DESIGN REVIEW/CERTIFICATE OF APPROPRIATENESS APPLICATION

STARBUCKS #10057 - MORSE & HAMILTON
PREPARED FOR
STARBUCKS

Kimley-Horn has reviewed the comments provided by the Gahanna Department of Planning, OH dated January 25, 2023 and has modified the plans accordingly. The comments and responses are listed below. Responses to comments are in ***bold italics***.

The applicant is requesting approval of a Design Review to reconfigure the drive thru and landscaping at an existing Starbucks location. There are no modifications proposed to the existing building itself. The site is located at 1370 N Hamilton Road and is zoned CC-2 – Community Commercial-Modified. It is on the eastern side of Hamilton Road, in front of the Market at Hamilton. The zoning designates the site as part of Design Review District 3 (DRD-3).

SHEET NUMBER
C200

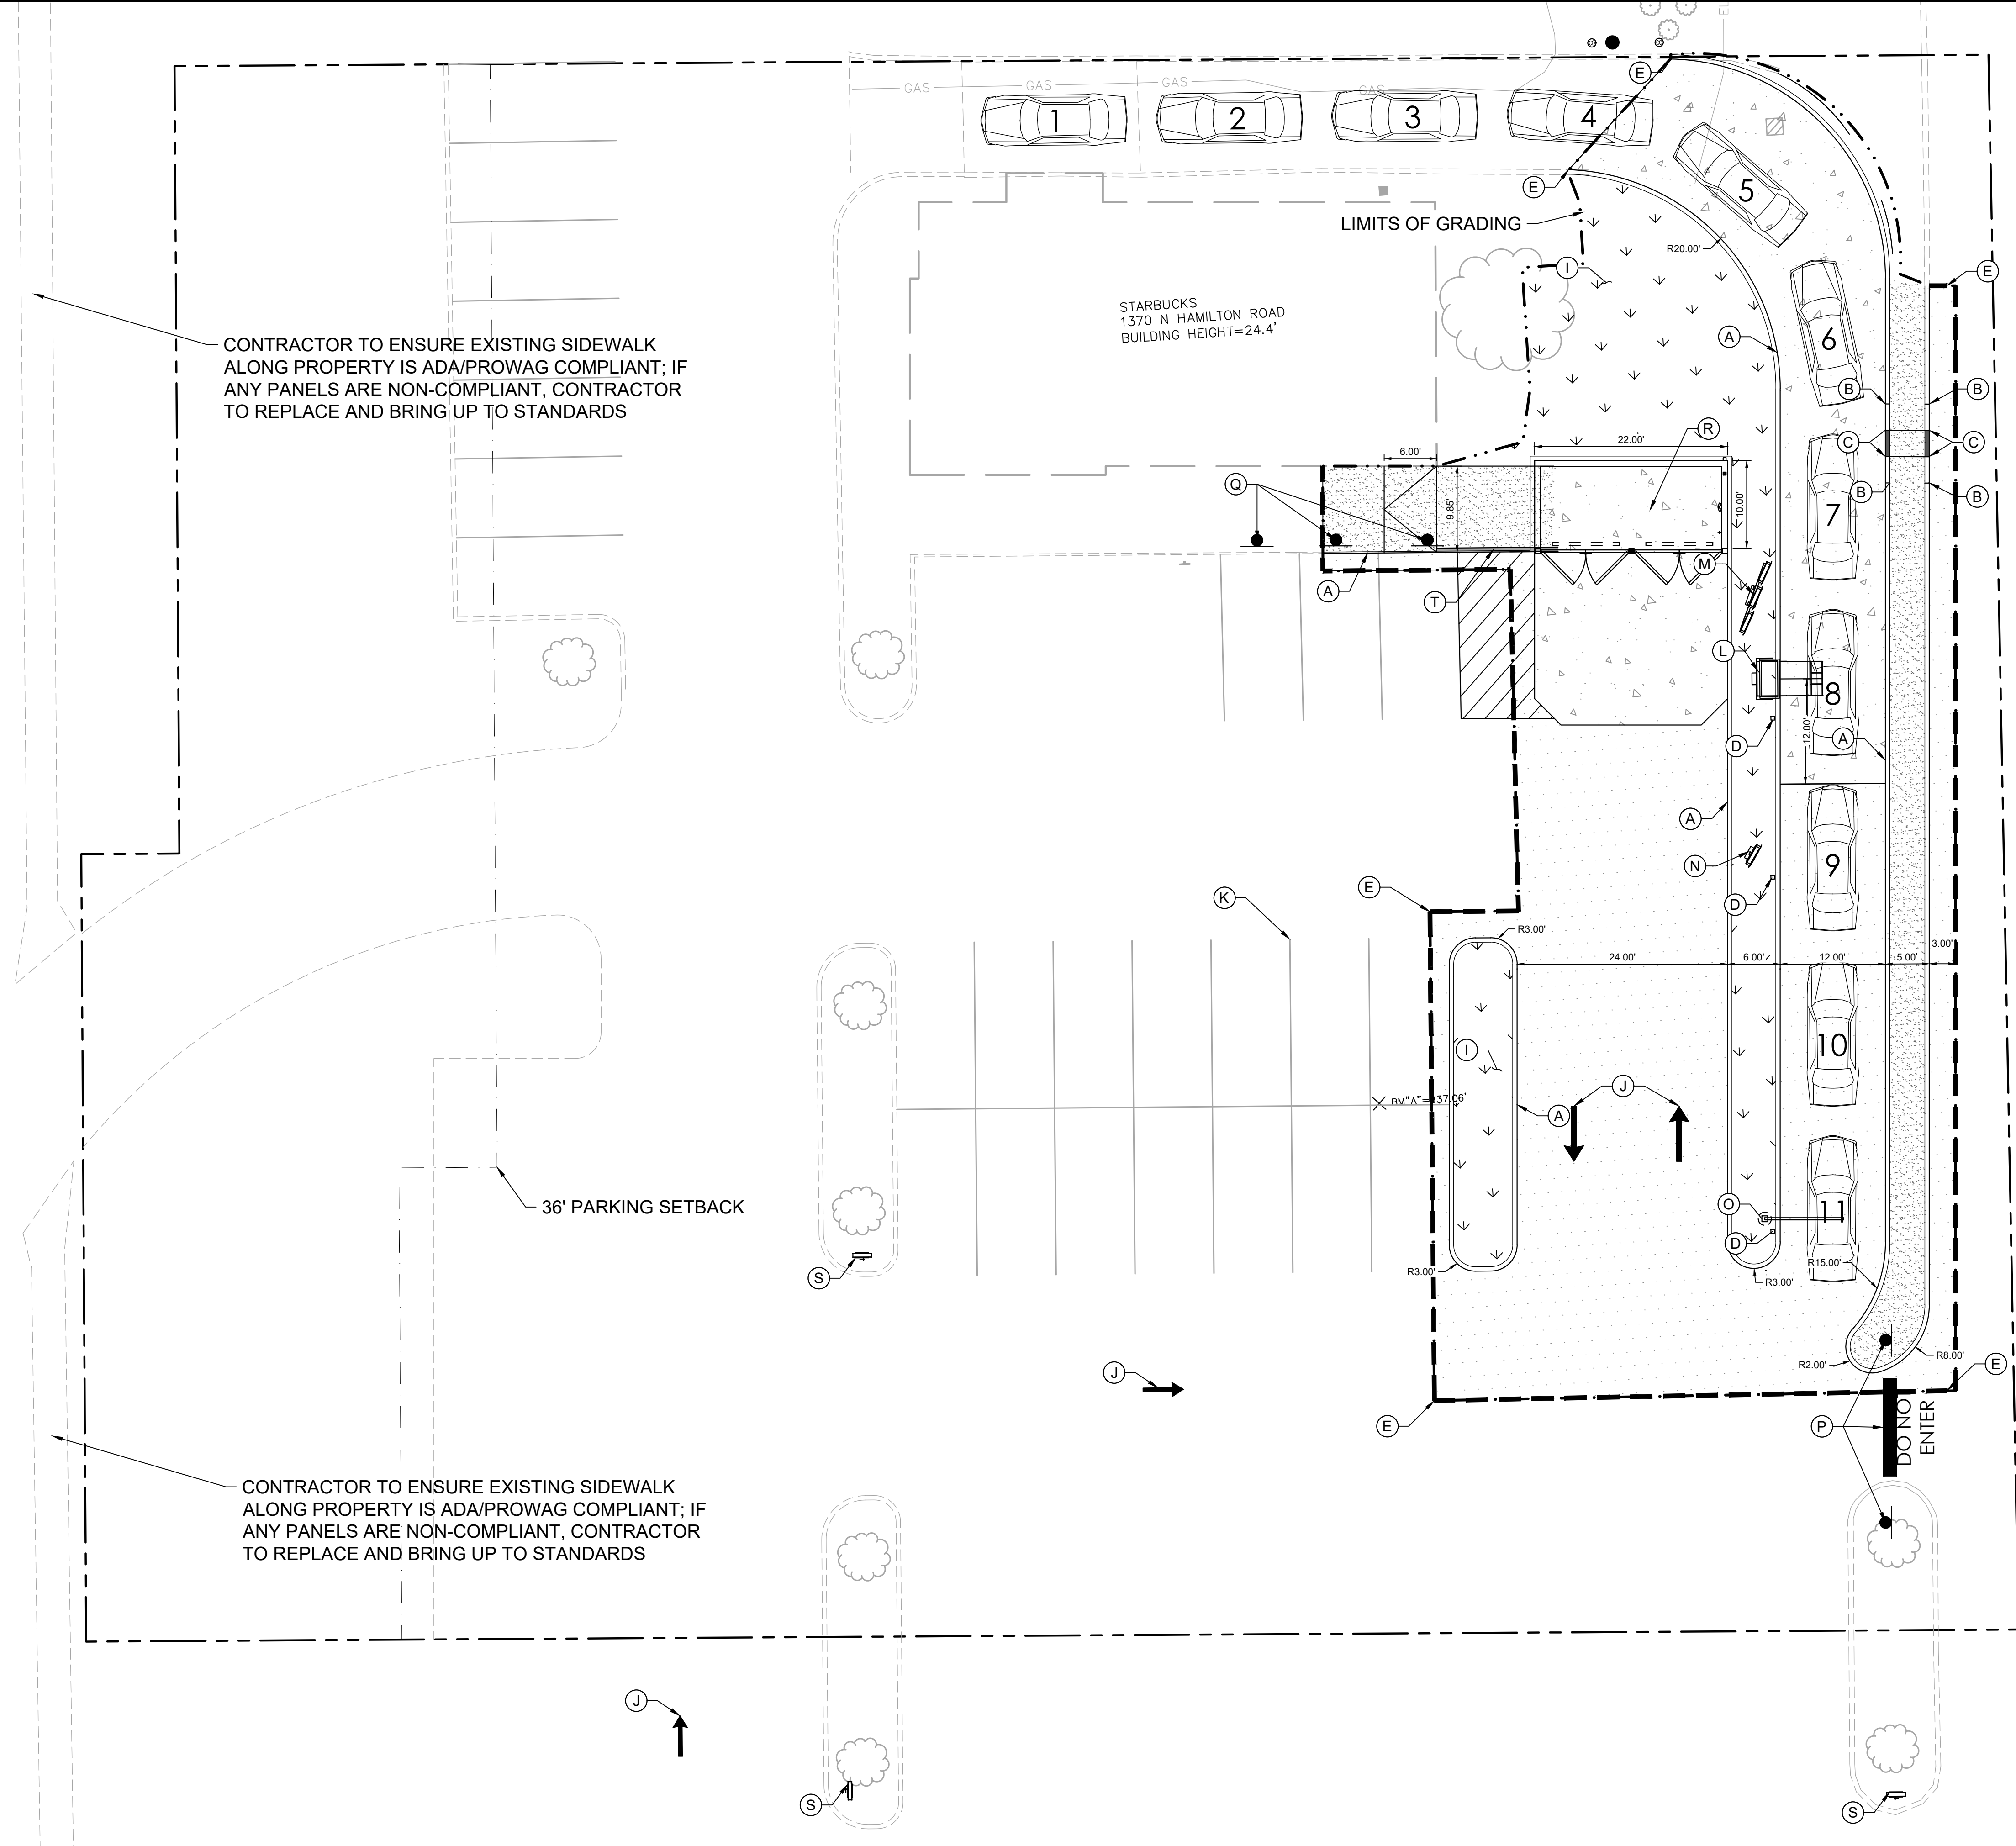
5. The property summary on C300 lists the total property area as 38,365 SF but the impervious and pervious area calculations do not add up to this number. Please update so the calculations are accurate. The total SF of the parking lot is necessary to determine how much landscaping and how many trees are required per Chapter 1163.08(c-e).
The property summary table on the Site Plan sheet has been updated to represent the full site area. The area is compliant with the landscaping requirements provided in Chapter 1163.08(c-e) of the City ordinance.

8. Sidewalk along Hamilton Road to be evaluated for ADA/PROWAG compliance; any defective panels or accessible non compliance shall be brought up to standard
The sidewalk along Hamilton Road has been noted to be reviewed for ADA compliance. A note has been provided for the contractor to replace any non-compliant

CONTRACTOR TO ENSURE EXISTING SIDEWALK ALONG PROPERTY IS ADA/PROWAG COMPLIANT; IF ANY PANELS ARE NON-COMPLIANT, CONTRACTOR TO REPLACE AND BRING UP TO STANDARDS

CONTRACTOR TO ENSURE EXISTING SIDEWALK ALONG PROPERTY IS ADA/PROWAG COMPLIANT; IF ANY PANELS ARE NON-COMPLIANT, CONTRACTOR TO REPLACE AND BRING UP TO STANDARDS

SHEET NUMBER
C500

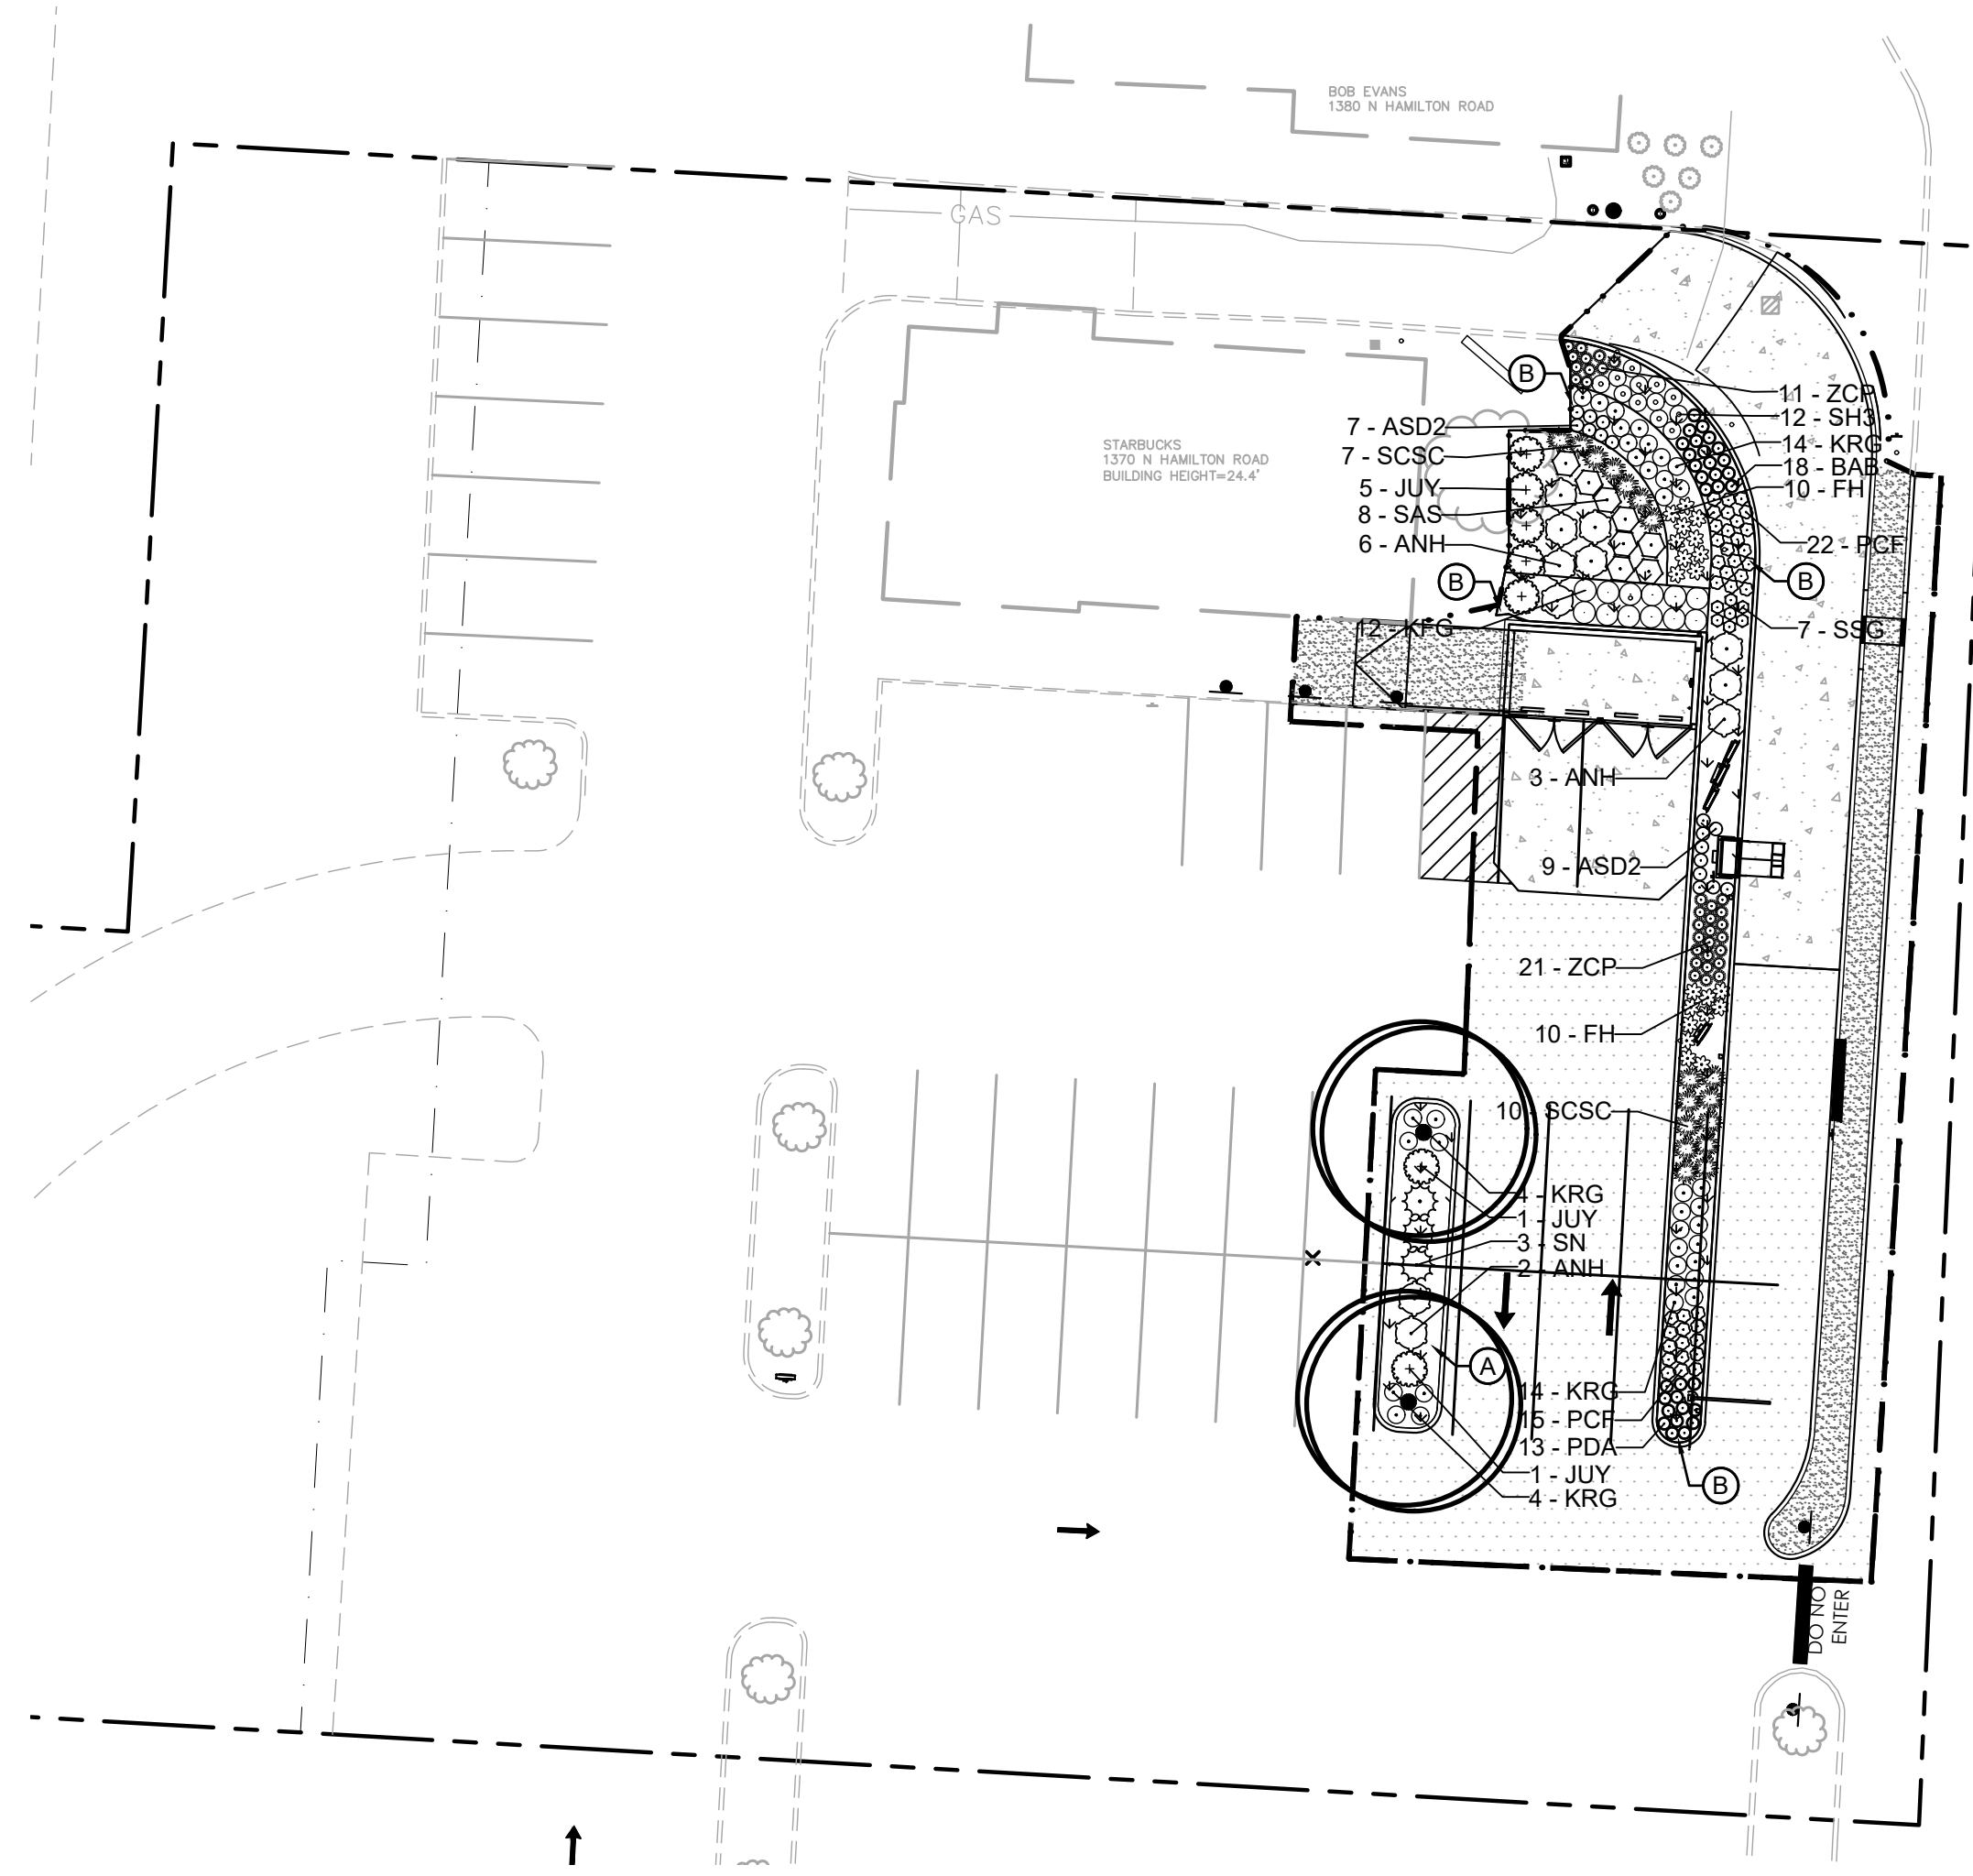
3. Informational Comment: Parking requirements are still met with the proposed removal of spaces.
The comment has been acknowledged.
4. Per application requirements, please update the landscape plan to include all of the existing trees and shrubs that are to remain on the site. Please note that one tree of at least three caliper inches is required per 100 SF of landscape area, per Chapter 1163.08(e). If this requirement cannot be met, you may apply for a variance.
We have proposed two 3" caliper trees within the parking island that is being relocated.

1. It appears as though trees are being removed, and impervious surface is being added. However, I cannot find plans for new tree plantings in this landscape plan. "All projects for which as FDP is required in which there are new structures, parking areas, loading areas, or other impervious surfaces shall plant a minimum of one shade tree caliper inch per 1,000 square feet of impervious surface unless located within the Planned Industrial District (PID) zoning districts." (914.05 – Minimum Trees Required). Unless I am mistaken, plans should include new trees.

4. The response to the comment letter states that 2 trees are being planted on site, L100 shows 2 trees, but the chart on L100 lists three trees to be planted. Please update for consistency.
The Landscape Plan has been updated to correspond the proposed trees between the plan and the planting schedule.

1 TREE PLANTING DETAIL
SCALE: N.T.S.

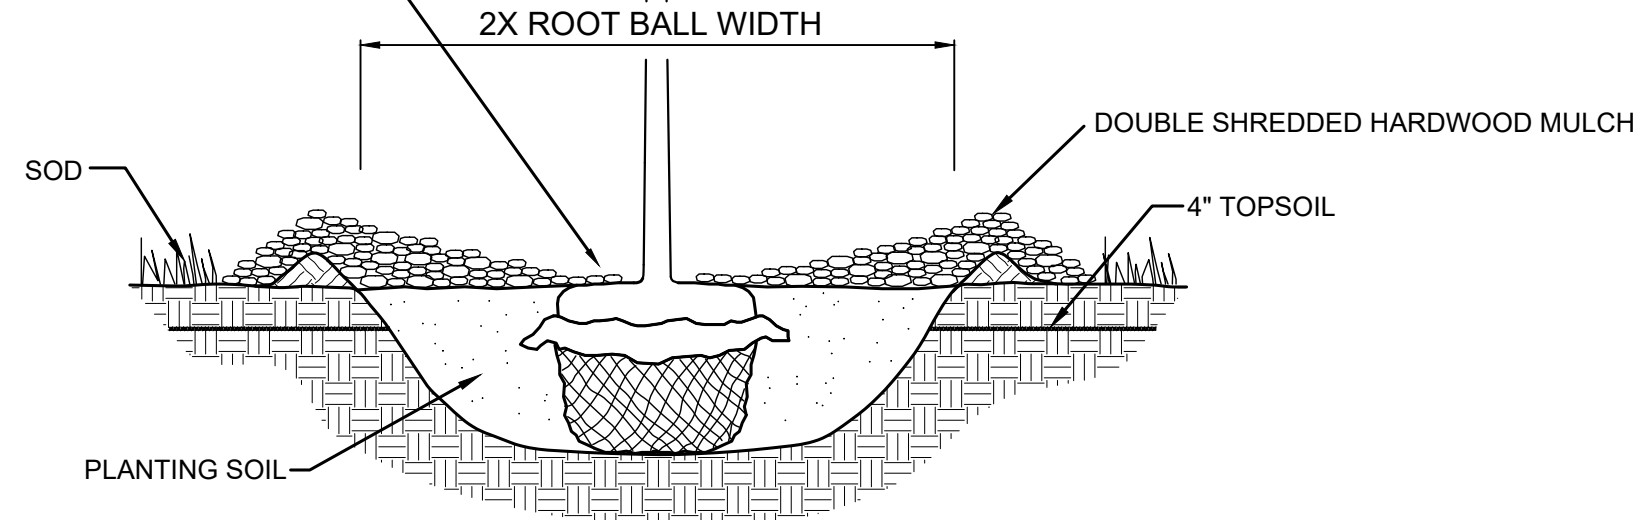
9. I see that the tree planting detail shows the mulch pulled back away from the trunk, but I'd like to see that written in the notes
The tree planting detail has been updated to provide a callout to pull the adjacent mulch back from the trunk base and a note has been provided.

10. FINAL LOCATION OF TREE TO BE APPROVED BY OWNER.
11. HARDWOOD MULCH AT THE BASE OF PROPOSED TREES IS TO BE PULLED AWAY FROM THE TRUNK.

MULCH AROUND TREE TRUNK BASE TO BE PULLED BACK AWAY FROM TRUNK BASE
